Approved Modifications to Previously Approved Scheme SD20A0283

Approved and Proposed Sections
 DUB 15 Data Centre

Scale: As Indicated
 Role: Architectural
 Status: CS - Suitable for Information - Planning
 Drawing No: 279225
 Project No: A1200 - 15

1- Section - As Approved - Section A-A
 Scale: 1:250

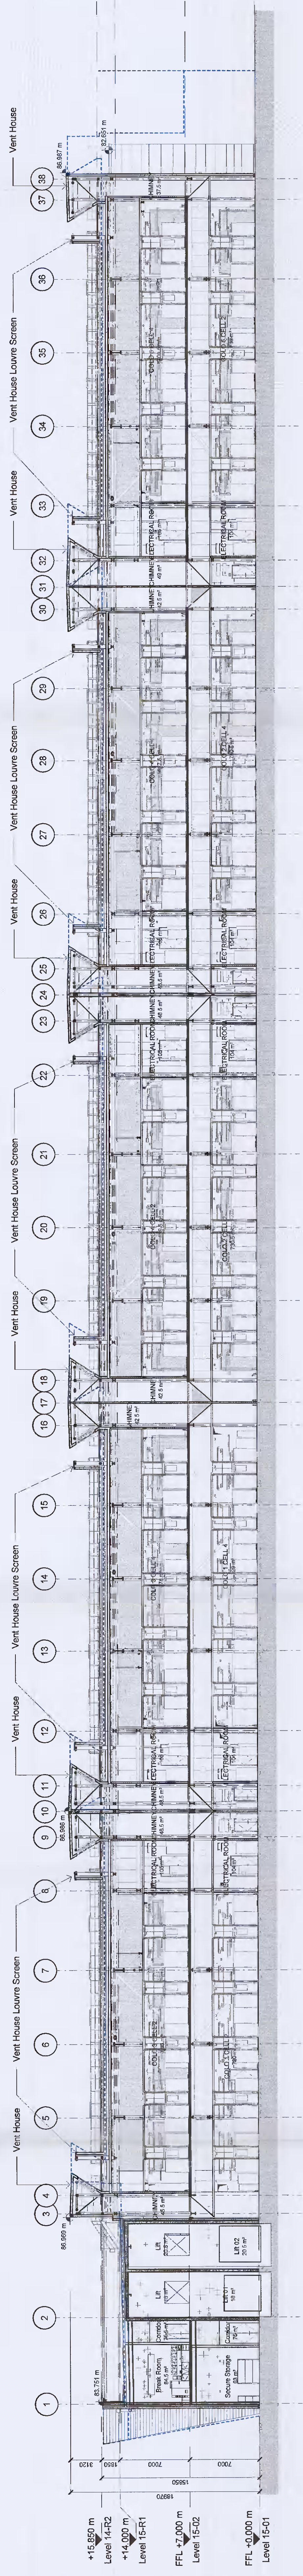
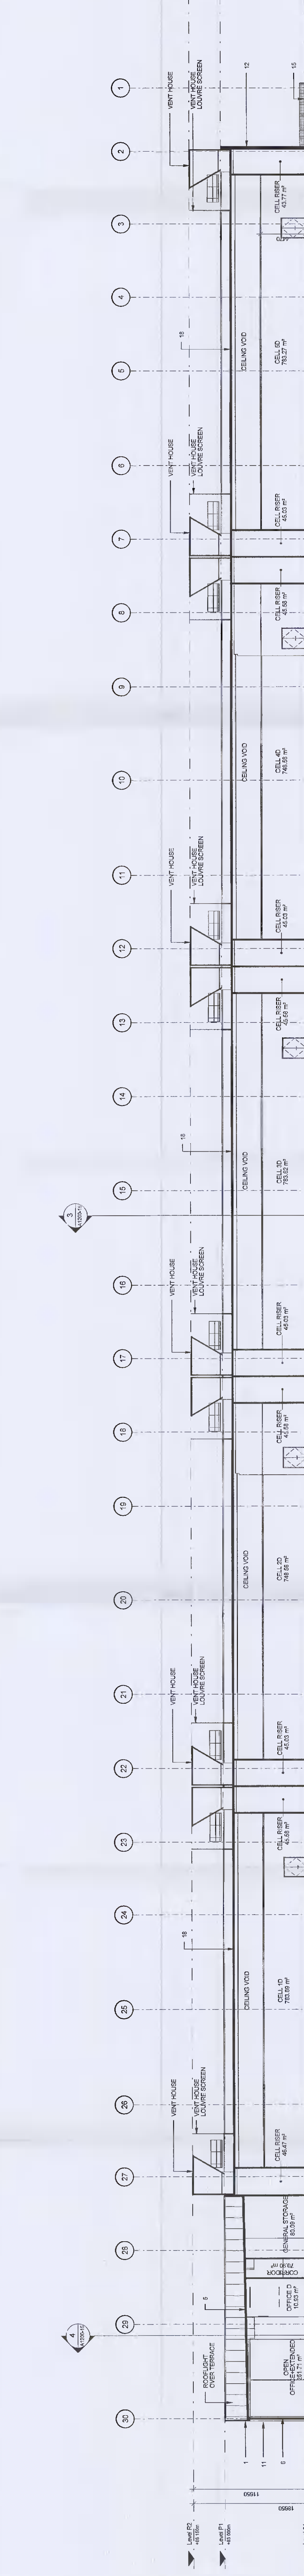
2- Section - Proposed - Section A-A
 Scale: 1:250

3- Section - As Approved - Section B-B
 Scale: 1:250

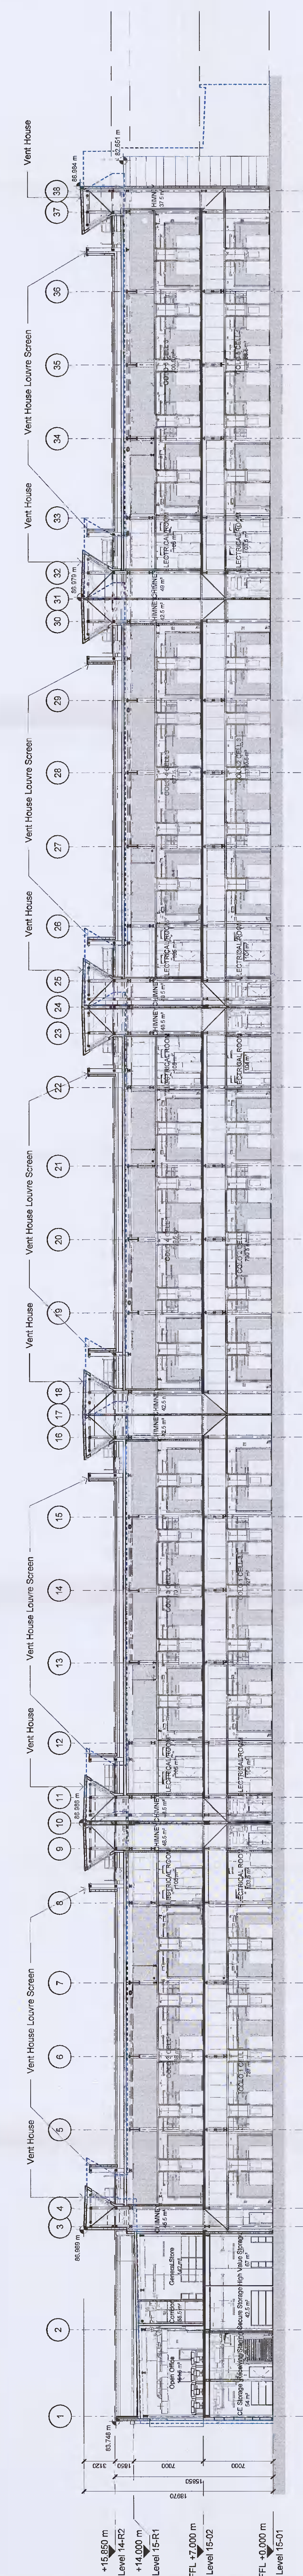
4- Section - Proposed - Section B-B
 Scale: 1:250
